TECHNICAL BULLETIN

Ref Document No.	TB13001	Issue No.	1
Subject	Park Brake Valve – Failure to Apply		
Release Date	21 st October 2013

Applies to all COALTRAM® CT08, CT10 and CT13 vehicles.

Figure 2 - Cross Section Pilot End Cap/Piston Assembly

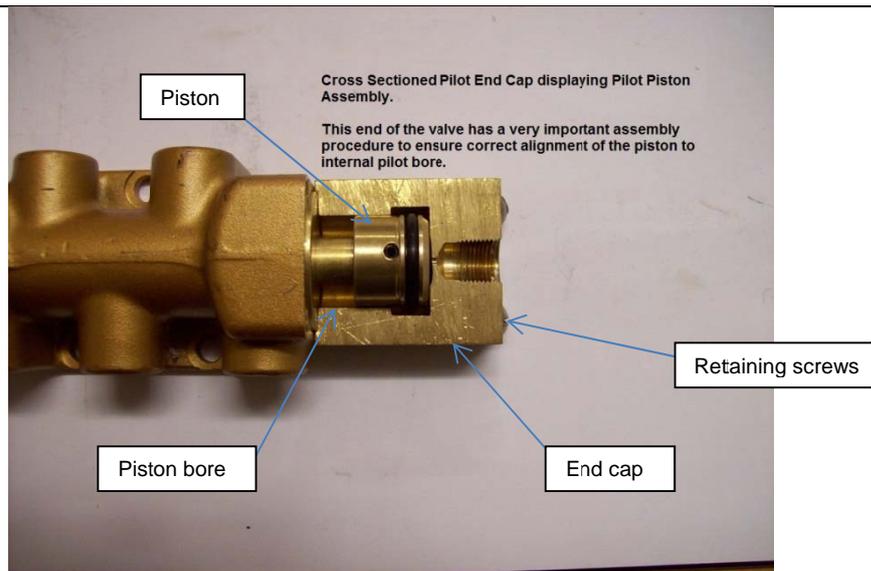
The cause of the malfunction in the valves was a lack of lubrication and misalignment of the end cap and pilot piston assembly. A cut away view of the end cap and piston assembly is shown in Figure 2 below.

The pilot piston to spool connection is a floating design which allows the piston to centralise and align itself when entering the pilot end cap bore upon actuation. Both the pilot piston & pilot end cap were measured & complied with the respective manufacturing drawings. Whilst the pilot end caps were without the 2mm x 45 degree internal pilot bore chamfer (recently introduced at the end of 2012 to improve the operation of the pilot assembly, but not rendering the original pilot end caps as unusable) the lead in edge was relieved of any sharp edges.

One VERY IMPORTANT assembly procedure with the pilot end of this V657 valve assembly is that when you fit the pilot end cap to the main 4 way valve section the valve MUST be actuated (pulled up). This will engage the pilot piston within the bore of the pilot end cap thus aligning & centralising the assembly. With the valve actuated the 4 retaining screws should be tightened.

1. Remove park brake valve from Coaltram at next available service opportunity, remove end cap, lubricate with Dow Molykote 55 O-ring grease and reassemble with appropriate alignment when reassembling.
2. Ensure all maintenance staff are made aware of correct assembly technique for fitting pilot end cap as per above description.
3. Complete park brake tests as per service sheets.
4. Refer SWP CT6.51 Park Brake Valve Lubrication for checking and lubricating park brake pilot end cap and piston.
